Protecting against the error floor

P802.3db Draft 3.1 comment R1-11

Piers Dawe, Nvidia

June 2022

Range of possible waterfall curves

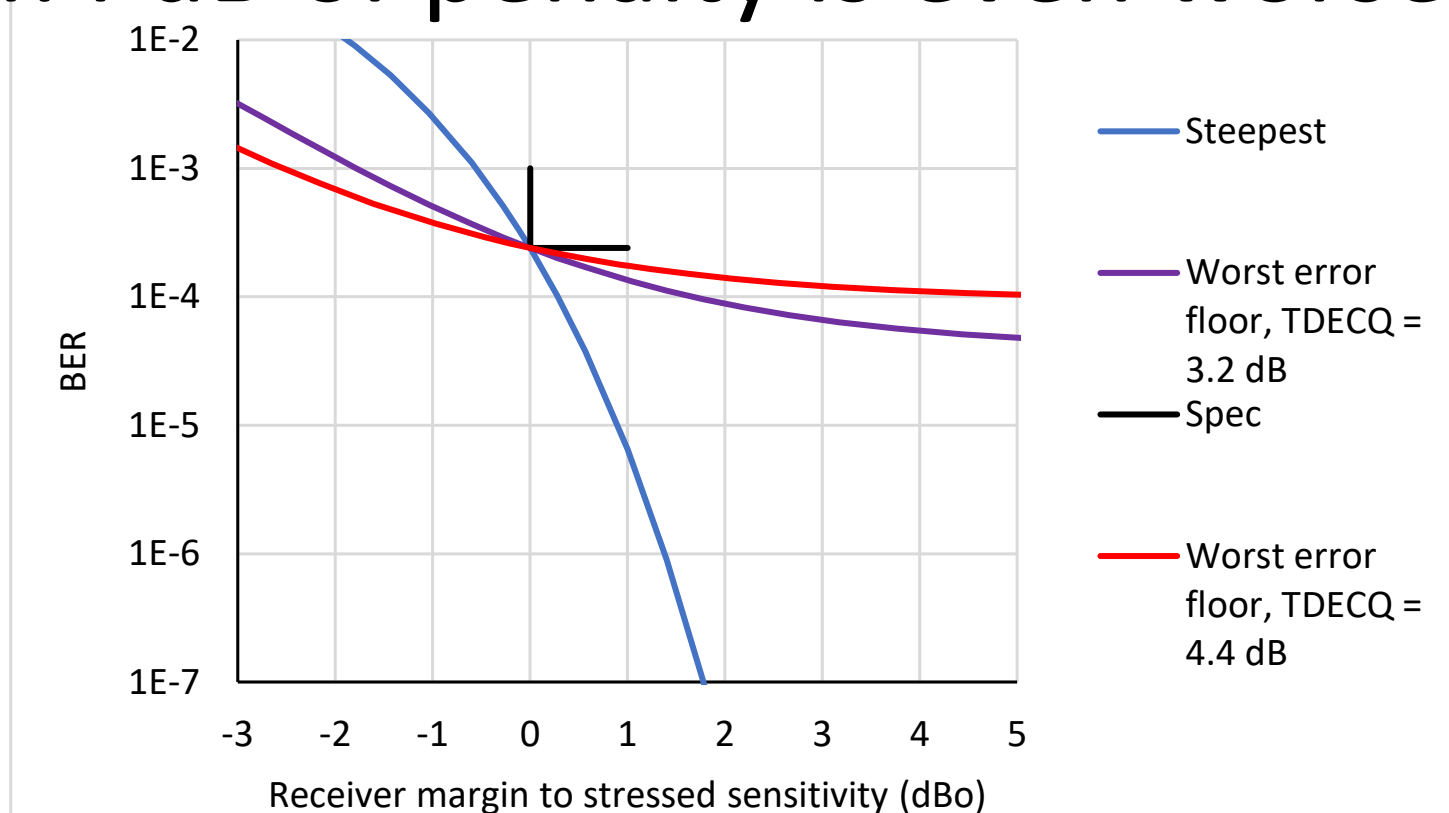
- Two transmitters with the same 3.2 dB TDECQ (the limit finally adopted for the first PAM4 optical PMDs)
 - Blue one has high-probability (narrow distribution) impairments, purple one has Gaussian impairments
- A receiver deals with this with better sensitivity
- The theoretical worst error floor (asymptote) for 3.2 dB of unfortunate K is $3.8e-5$

4.4 dB of penalty is even worse!

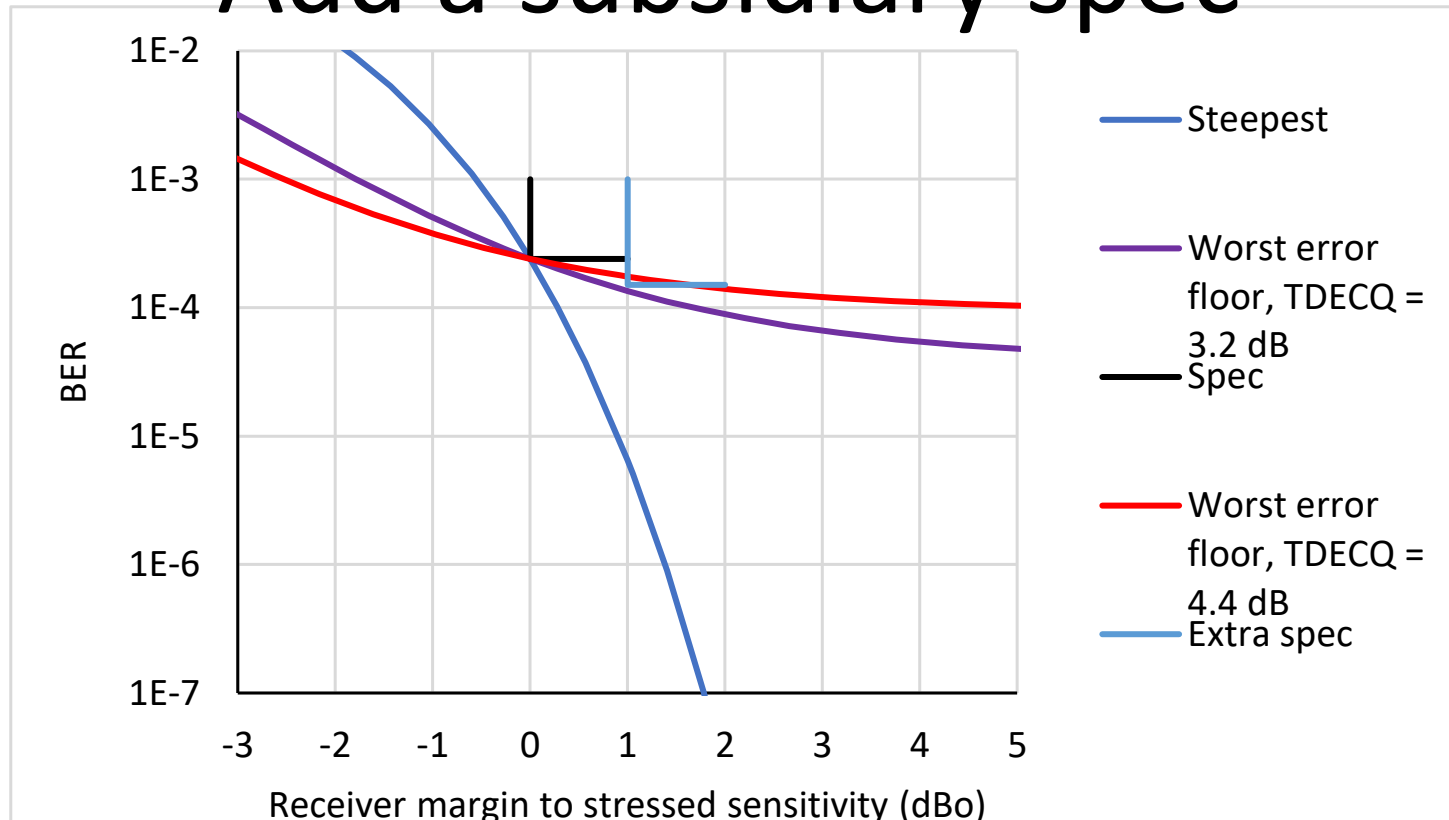
- With 4.4 dB of TDECQ receiver needs more than twice the better sensitivity to get to a reasonable BER
 - To be more precise, it's an unfortunate transmitter with 4.4 dB of K
 - $TDECQ = K + C_{eq}$, all in dBo
 - The theoretical worst error floor (asymptote) for 4.4 dB of unfortunate K is $9.3e-5$
- As what we care about is to the right of the nominal spec, put another spec there
